DA (AMENDED)

67 PP
67 Pacific Parade DEE WHY NSW 2099

DRAWING TITLE
SITE CONTEXT PLANS

DRAWING TITLE
GENERAL
ARRANGEMENT -
LOWER GROUND
PLAN

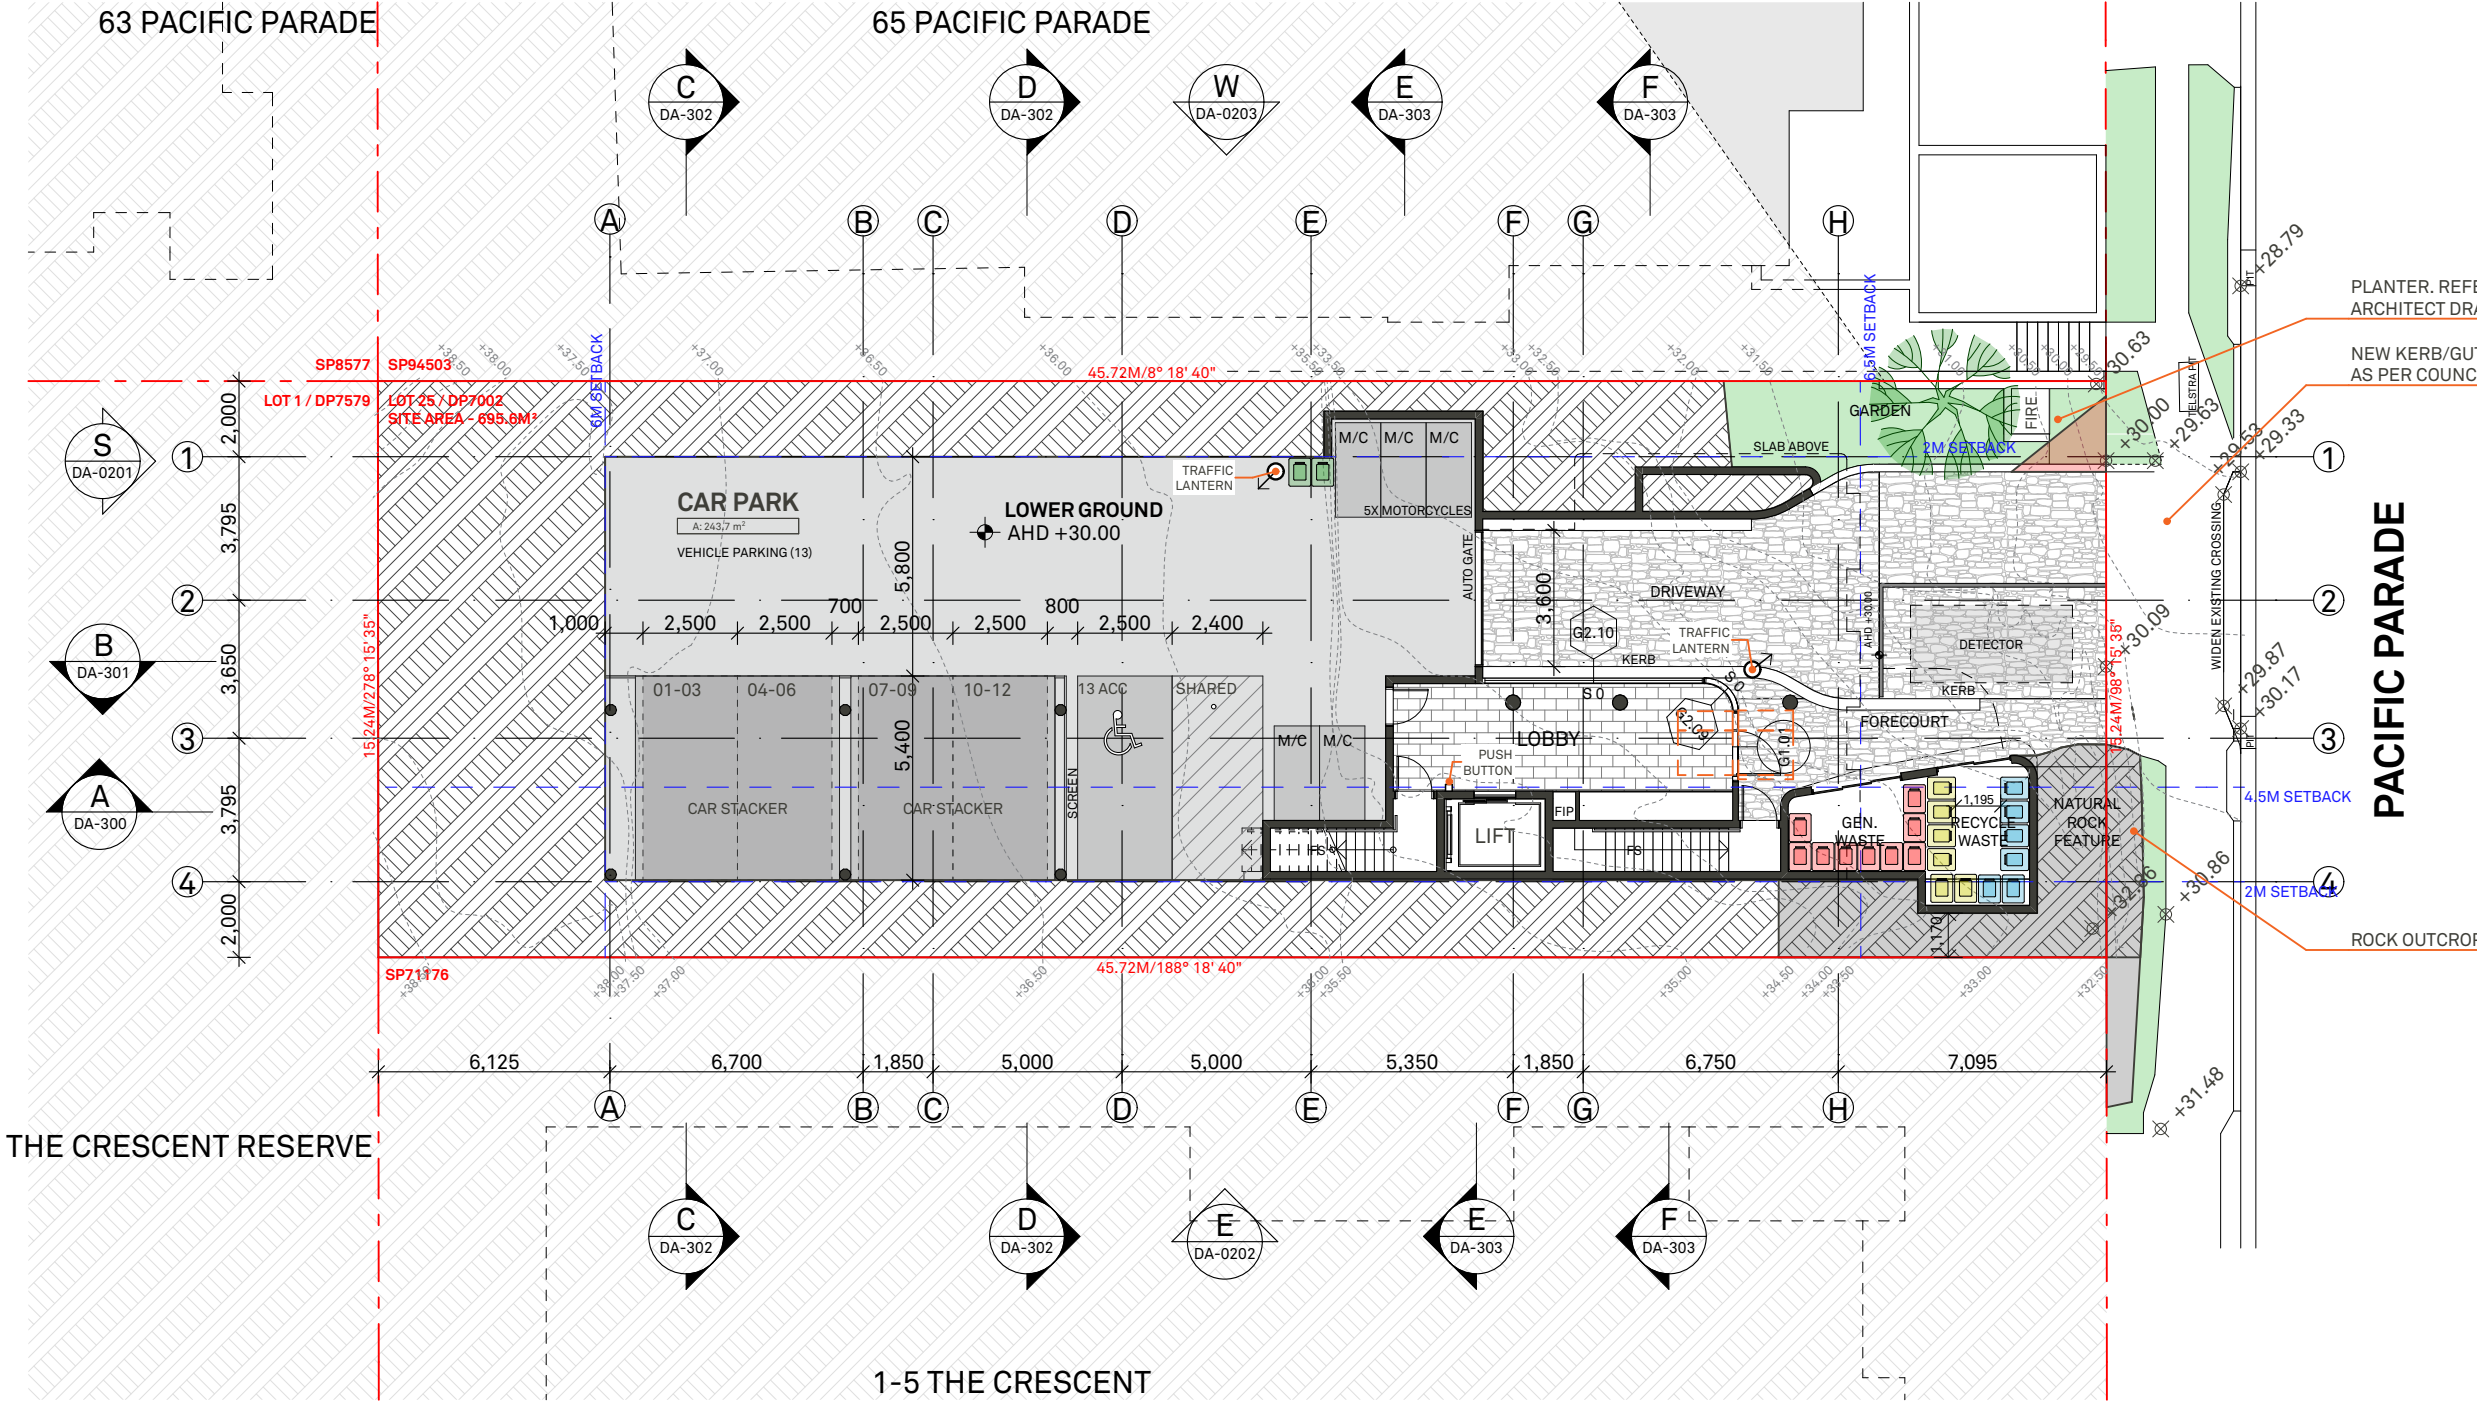
- 01 REMOVE VEHICULAR ACCESS TO BASEMENT;
INSTALL CAR STACKING MECHANISM (12 CARS);
INSTALL INTERNAL TRAFFIC LIGHT SYSTEM;
PROVIDE 1x ACCESSIBLE CAR SPACE; 5x MOTOR-
CYCLE SPACES; WIDEN VEHICULAR CROSSING;
INCREASE LANDSCAPING AREA AND INCREASE SOIL
DEPTH IN SOME AREAS; REMOVE GARBAGE
STORE AND REPLACE WITH HOLDING AREA

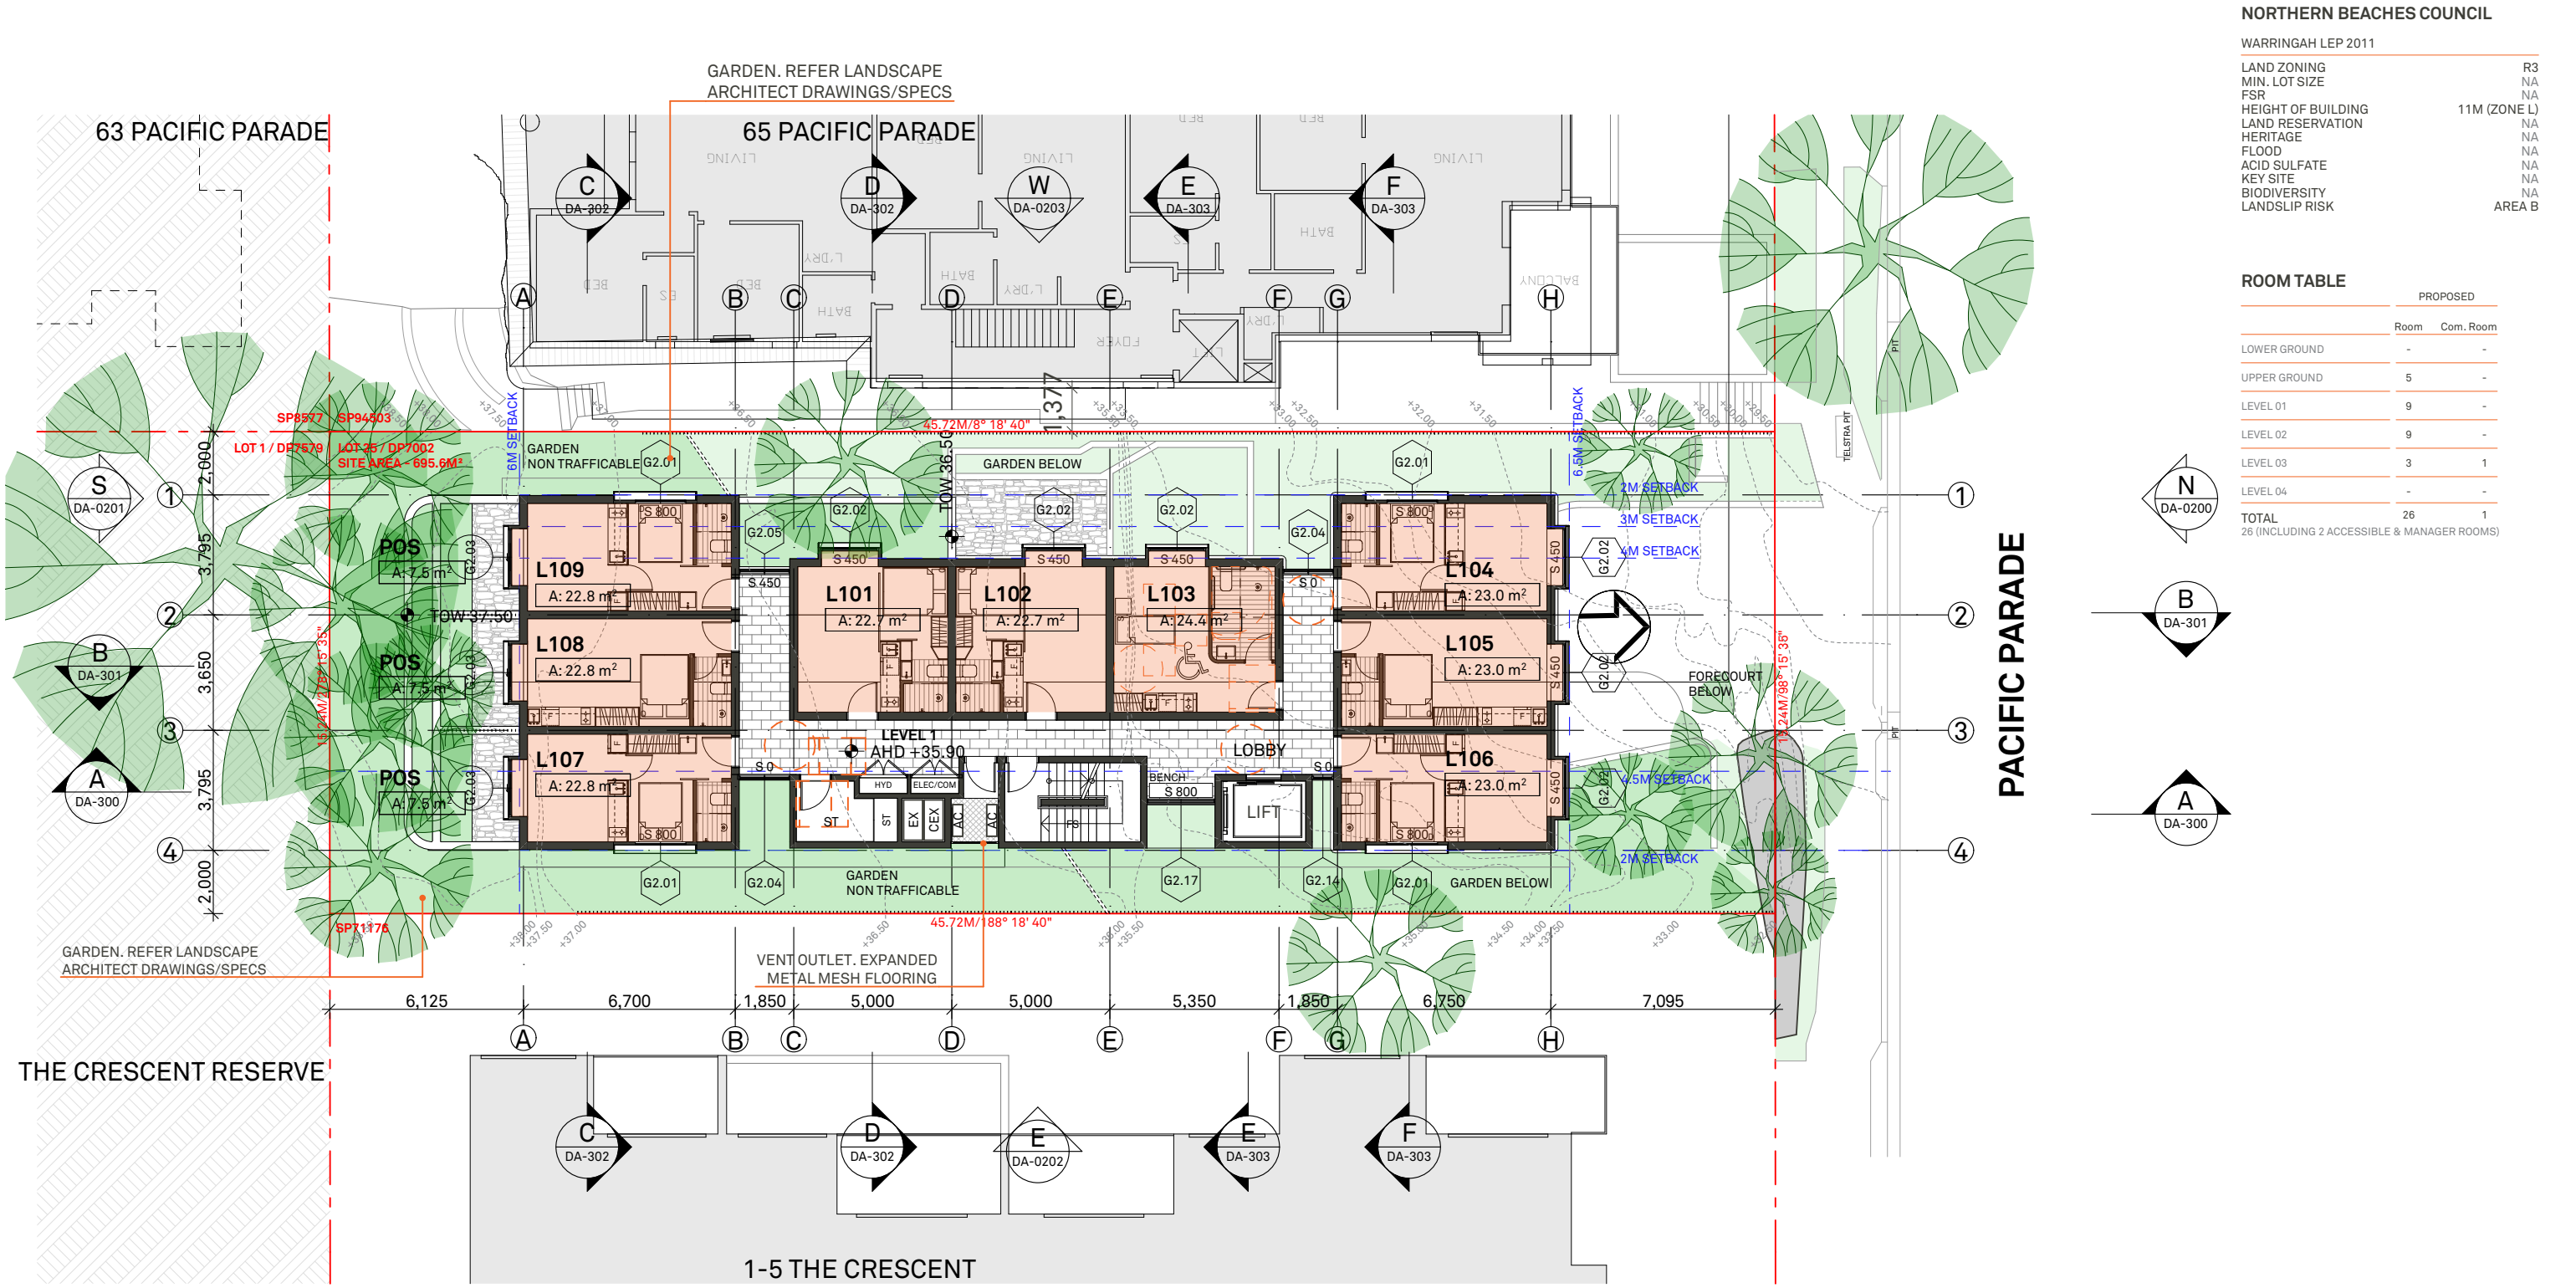
- 01 INSTALL CAR STACKING MECHANISM BELOW (VOID); RELOCATE COMMON ROOM; REMOVE 1x ROOM; INSTALL 6x BICYCLE SPACES; RELOCATE LAUNDRY; INSTALL GARBAGE AND BULK STORE WITH ADDITIONAL RECYCLING BINS; REMOVE TRELLIS AND INCREASE AT-GRADE LANDSCAPING AND SOIL DEPTH IN SOME AREAS; RE-LABEL ROOM NAMES

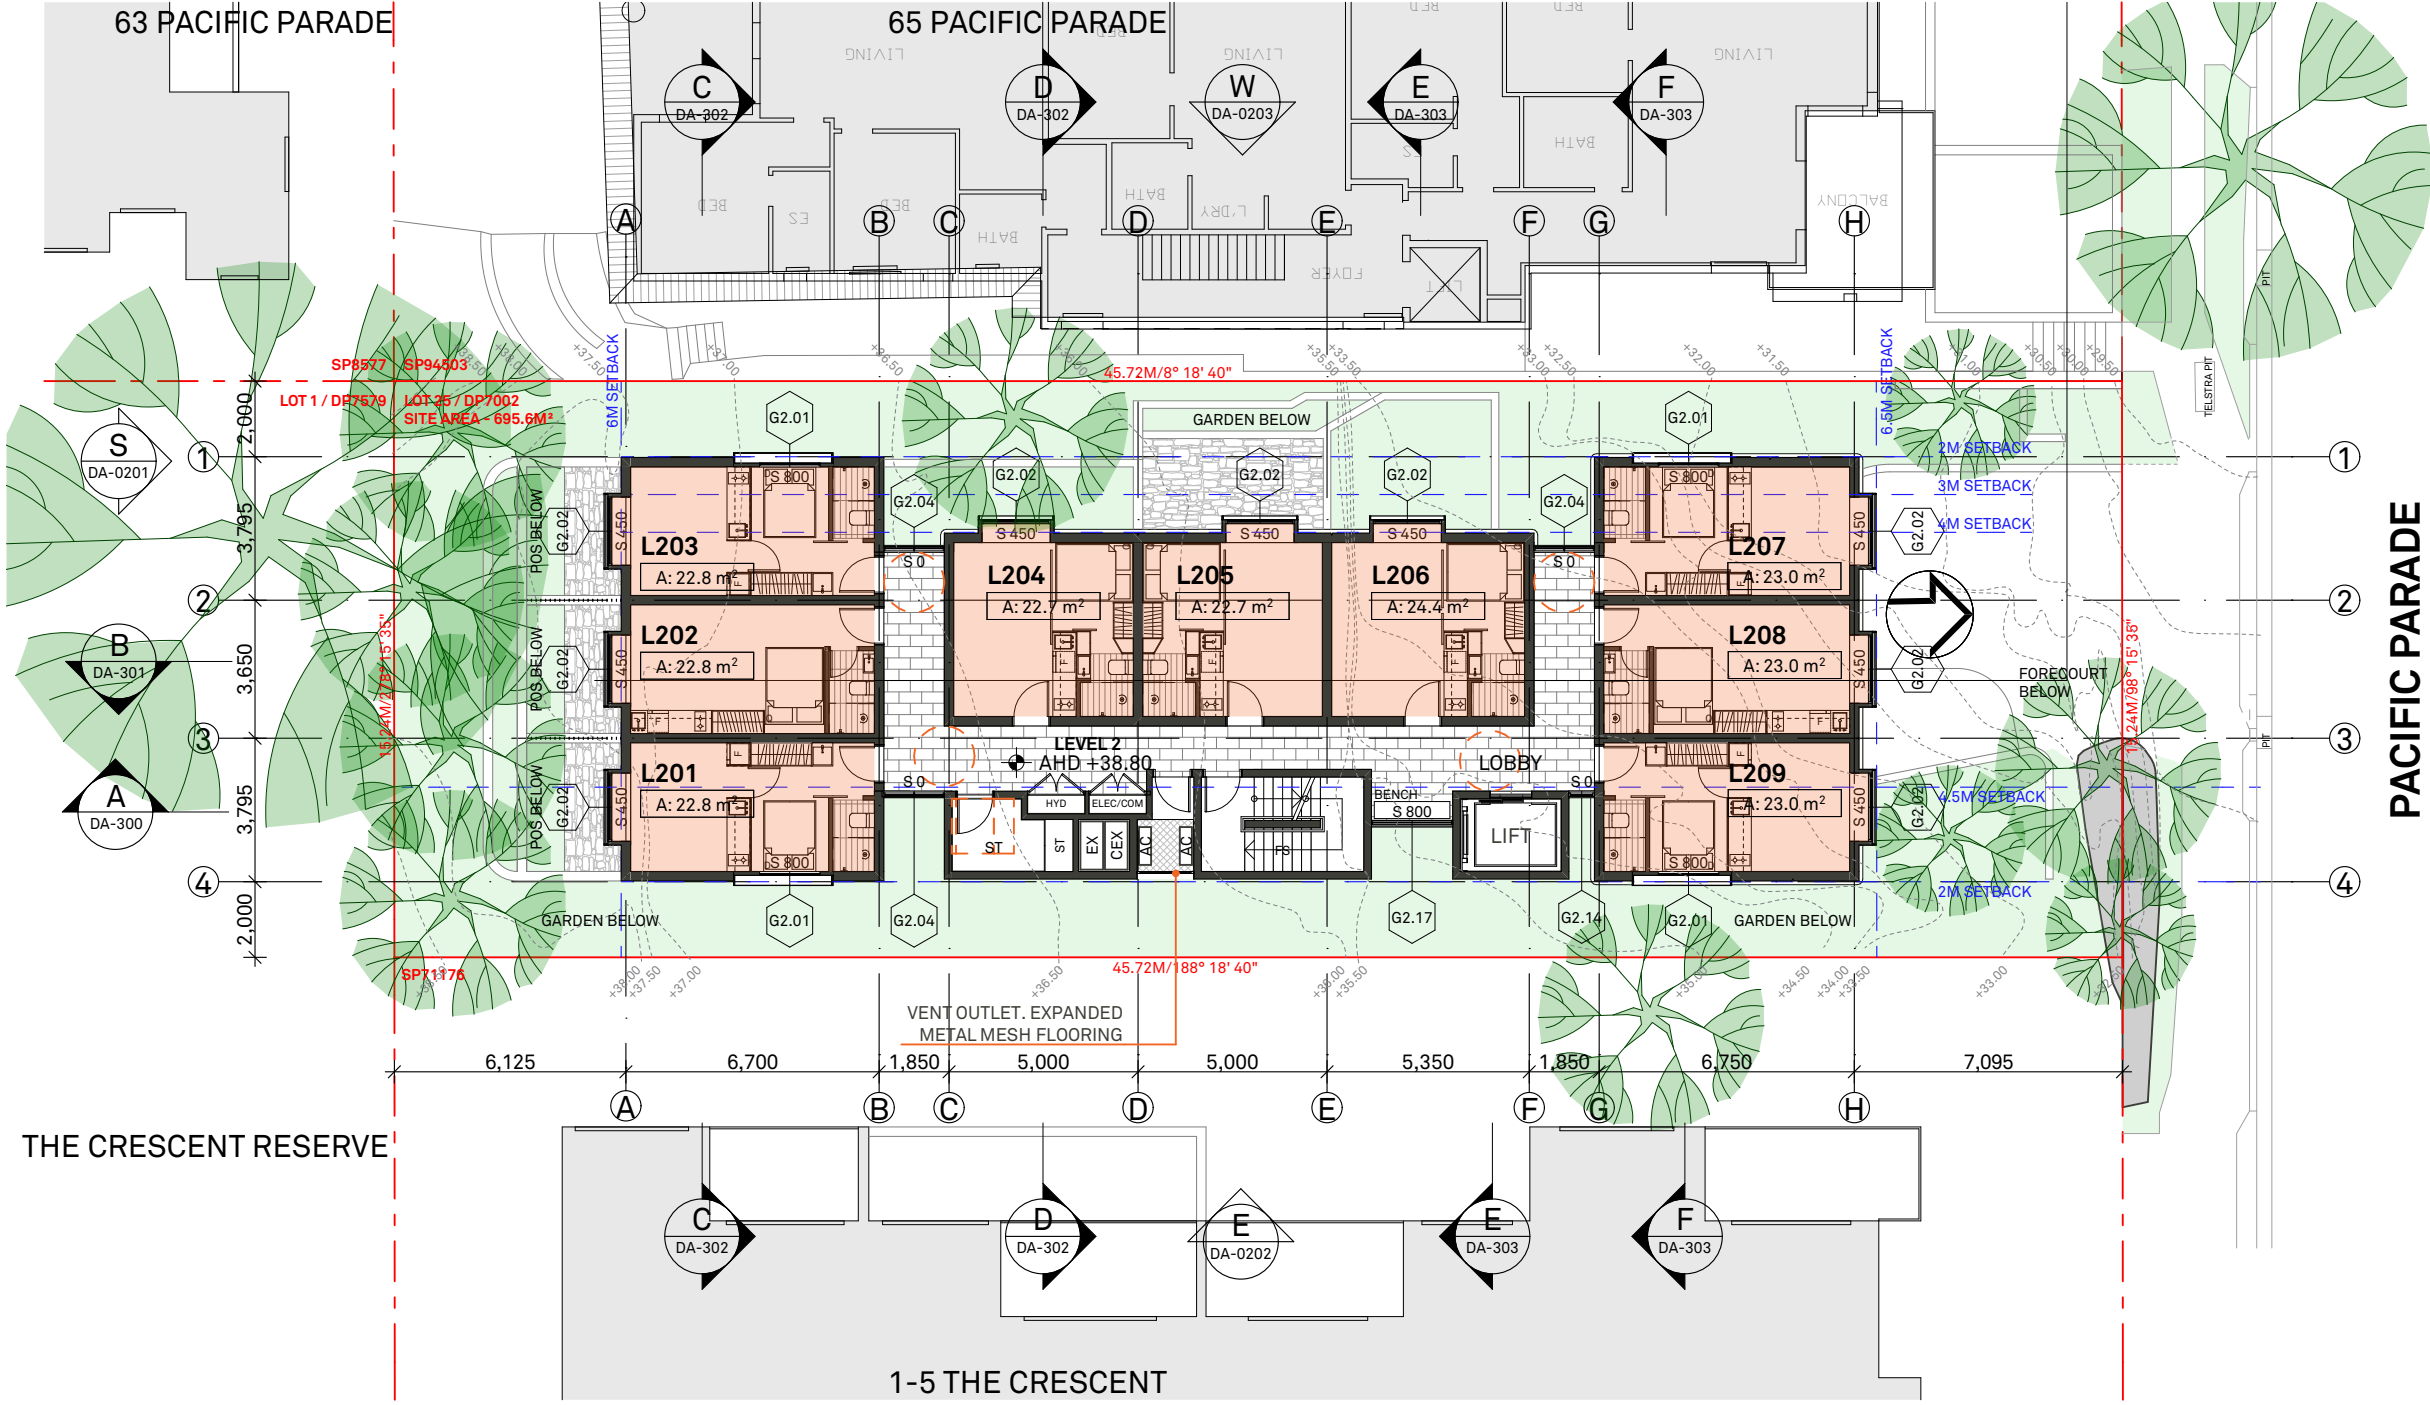
- 01 RELOCATE COMMON ROOM; INSTALL 3x ADDITIONAL ROOMS; REPLACE COMMUNAL OPEN SPACE WITH PRIVATE OPEN SPACE.
